Access Compliance Report

Public Rights-of-Way

(Curb Ramps)

Intersection ID: 43500	Main Street: MCALLISTER_PARK_DR	Cross Street: WILFORD_CT	Location: E
ADA ID: B8FFA5F50F67	Ramp Type: BlendTrans1	Initial Pass/Fail: Fail	Overall Compliance: No
Severity Score: 21.25			
Codes/Mitigation Info/Possible Solution		Field Measurements/Component Compliance

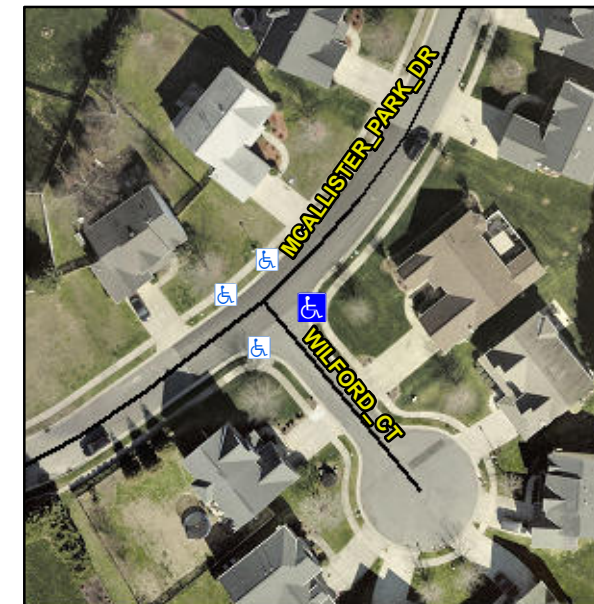
Not Found, R304.5.1, R304.5.3

Compliance	Description	Data	Compliance	Description	Data
N/A	Ramp Length (in)	50.0	Yes	BlendTrans Slope (%)	3.4
No	Ramp Width (in)	37.0	No	BlendTrans XSlope (%)	6.1
N/A	Flare Type LT	N/A	N/A	Flare Type RT	N/A
N/A	Flare Slope LT (%)	N/A	N/A	Flare Slope RT (%)	N/A
N/A	Flare Traversable LT?	N/A	N/A	Flare Traversable RT?	N/A
N/A	Landing Length (in)	N/A	N/A	DWS Provided?	N/A
N/A	Landing Width (in)	N/A	N/A	DWS Contrast?	N/A
N/A	Landing Slope (%)	N/A	N/A	DWS Length (in)	N/A
N/A	Landing X Slope (%)	N/A	N/A	DWS Full Width?	N/A
N/A	Landing Curb? (Y/N)	N/A	N/A	DWS Offset (in)	N/A
N/A	Shared Landing?	N/A			
N/A	Gutter Ponding?	N/A	N/A	Gutter Slope (%)	N/A
N/A	Gutter Lip Ht (in)	N/A	N/A	Gutter X Slope (%)	N/A
N/A	Painted X Walk1?	No	N/A	Painted X Walk2?	No
	X Walk 1 Direction	To NW		X Walk 2 Direction	To SW
	X Walk 1 Width (in)	N/A		X Walk 2 Width (in)	N/A
	X Walk 1 Slope (%)	2.6		X Walk 2 Slope (%)	0.8
	X Walk 1 X Slope (%)	2.2		X Walk 2 X Slope (%)	4.9

N/A	Ramp inside XWalk1?	N/A	N/A	Ramp inside XWalk2?	N/A
	Road Slope (%)	5.1		Clear Space?	N/A
	Road X Slope (%)	1.7	N/A	Clear Space to XWalk (in)	N/A
N/A	Any Obstructions?	N/A	N/A	Storm Grate/Utility Hazard?	N/A
	Obstruction Type			Storm Grate/Utility Type	
		N/A			N/A
			Yes	Surface Condition? (G/P)	Good
			No	Curb Slope (%)	9.1

Remove & Replace Curb Ramp With Two New Directional Ramps or Equivalent.
